MAG 208 Water Quality Management Plan
Small Plant Review and Approval
for

The Preserve at Goldfield Ranch Water Reclamation Facility

March 20, 2008

Responsive Modifications

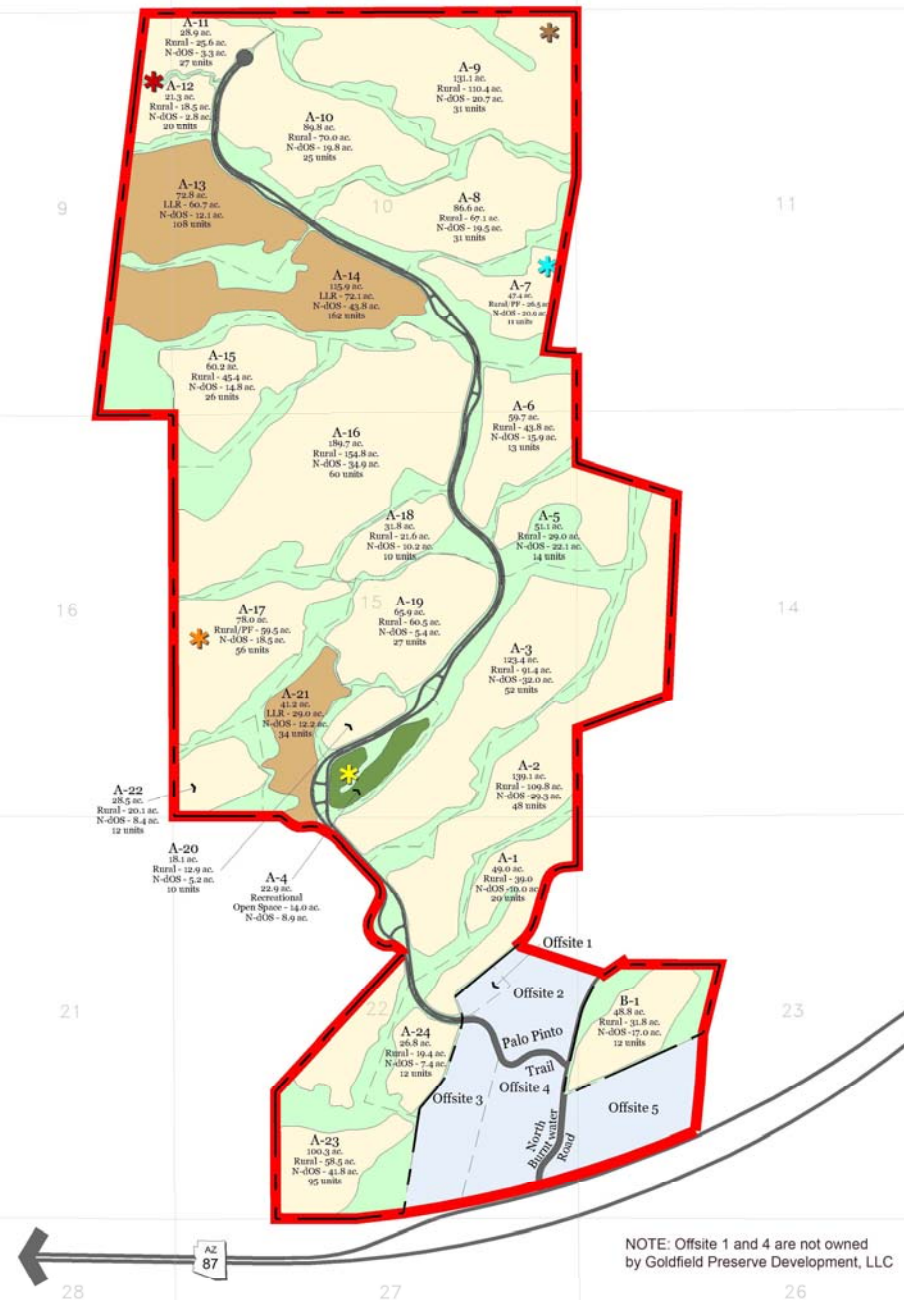
- Comment: Parcel B and additional offsite parcels should be included in service area
- Response:
 - Increase in service area from 1,680 acres to 1,902 acres
 - Population served of 3,283 persons
 - Maximum WRF capacity of 0.4 MGD sufficient

Tribal Comment and Response

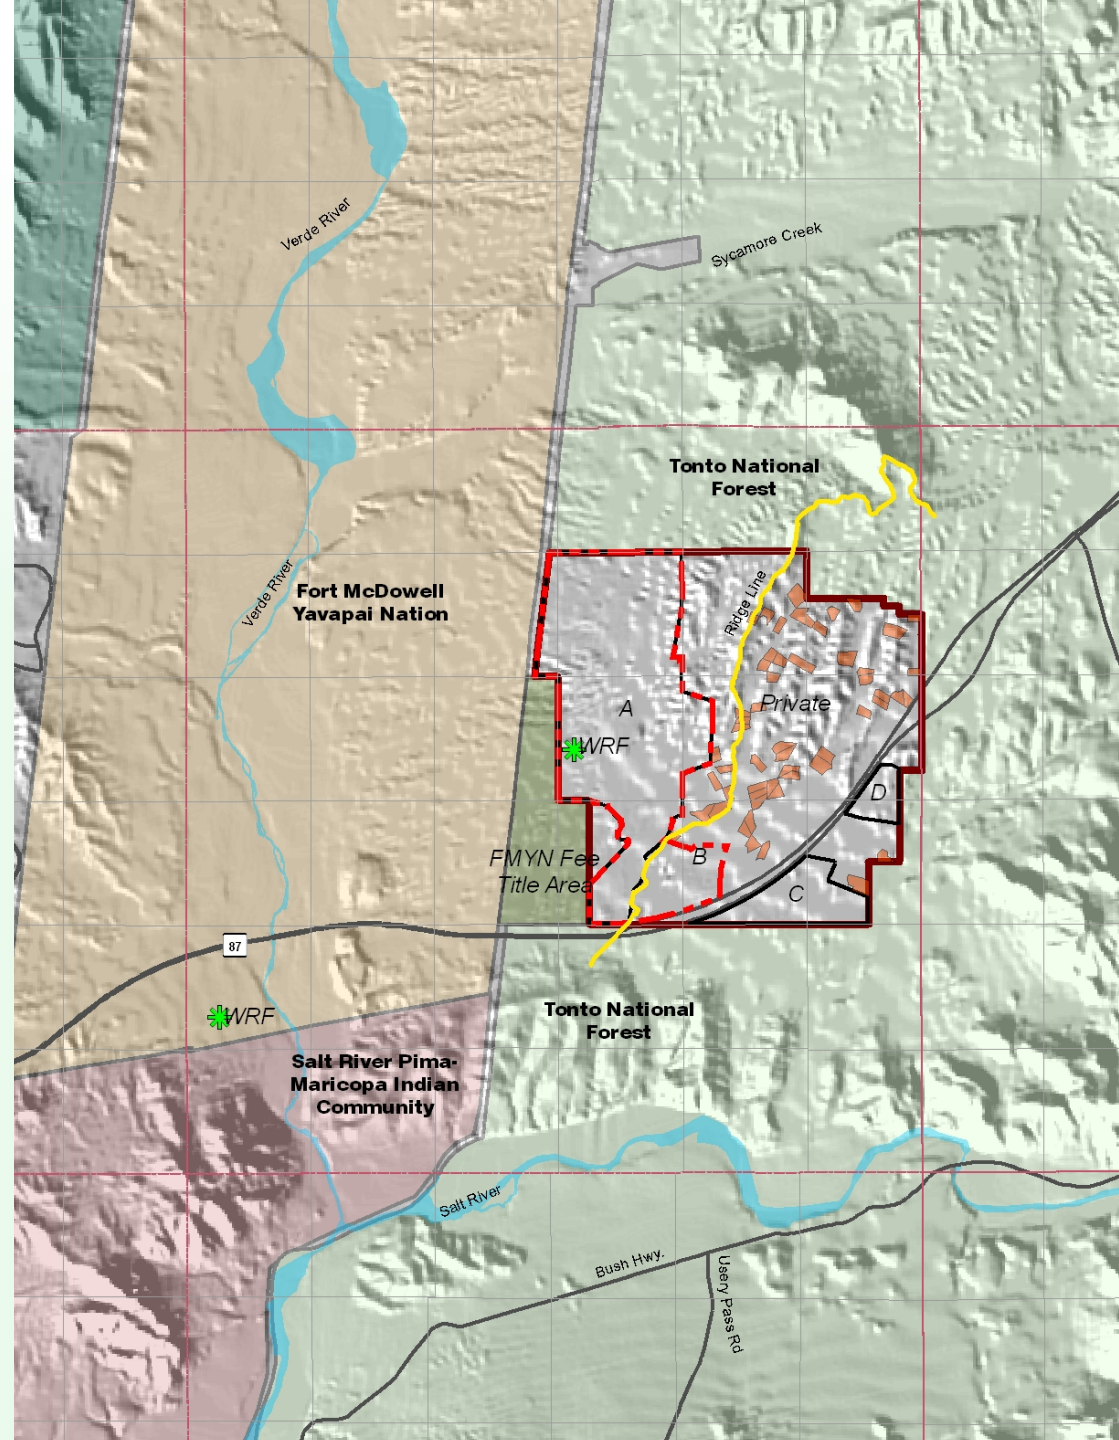
- Comment: Include
Parcels C and D
- Response:
 - Distance, topography,
jurisdictional waters
and State Route 87
constrain the
feasibility of serving
these parcels

Hydrogeologic Cross-Section

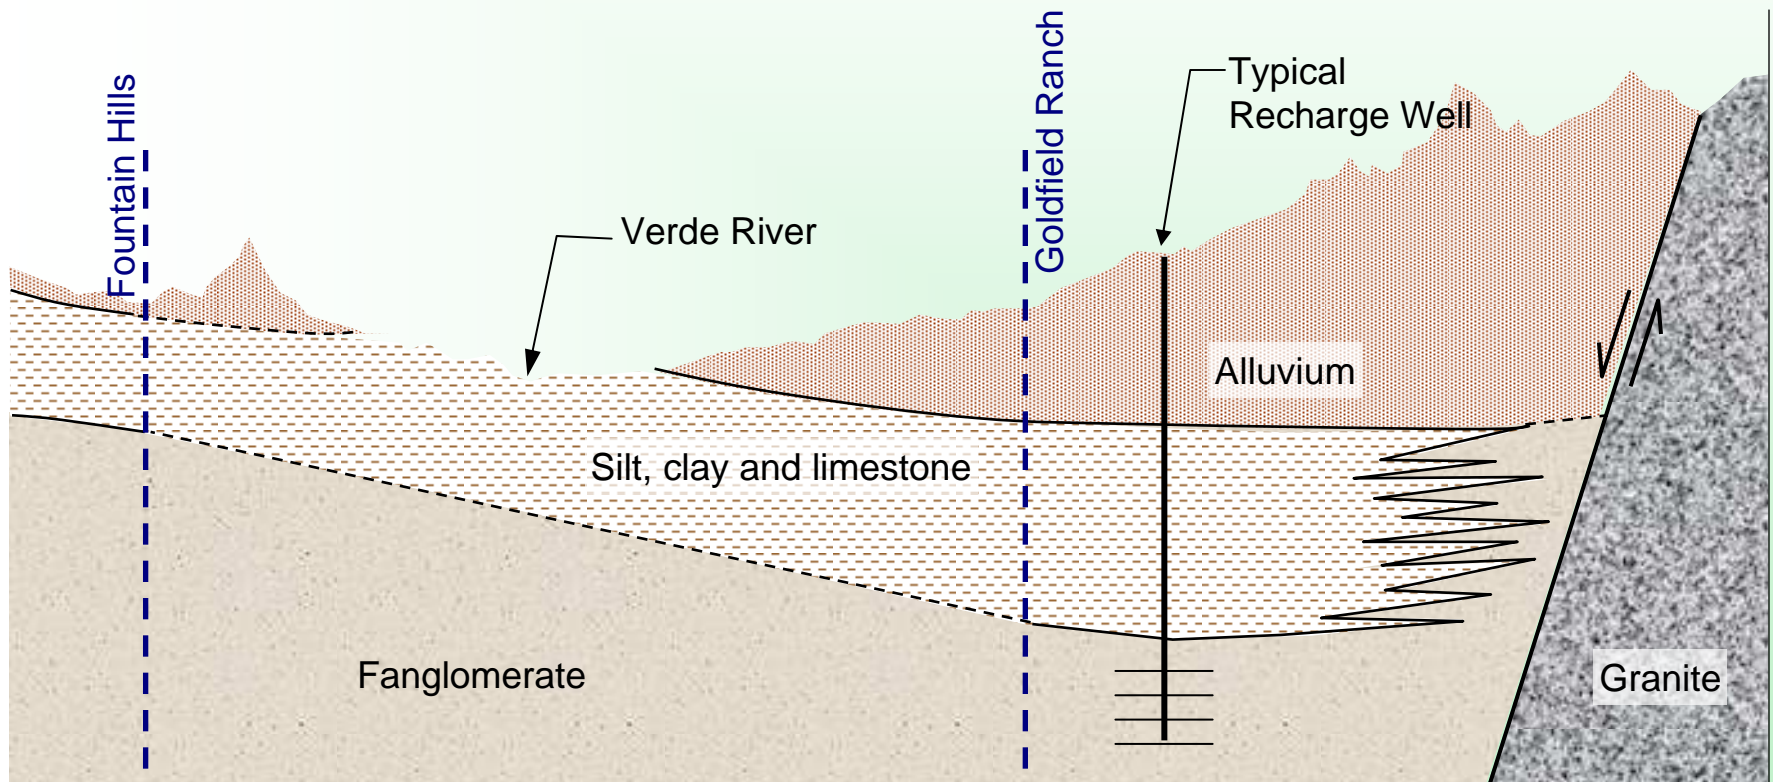
- Comment: Clay layer does not confine the upper and lower aquifer and thins out at the edges
- Response:
 - Well tests performed on site show aquifer is confined
 - Additional investigation is ongoing
 - Reference materials supporting presence of confining clay layer (playa deposit)
 - Pope, Jr. C.W. 1974. *Geology of the Lower Verde River Valley, Maricopa County, Arizona*. M.S. thesis, Arizona State University (LD 179.151974P66)
 - Skotnicki, S.J., E. M. Young, T.C. Goode and G.L. Bushner 2003. *Subsurface Geologic Investigation of Fountain Hills and Lower Verde River Valley, Maricopa County, Arizona*. Arizona Geological Survey Contributed Report CR-03-B.
 - E.L. Montgomery & Associates, 2004. *Physical Availability Determination in Support of a Modification of Designation of Assured Water Supply for Chaparral City Water Company, Fountain Hills, Arizona*. Consultant's Report.
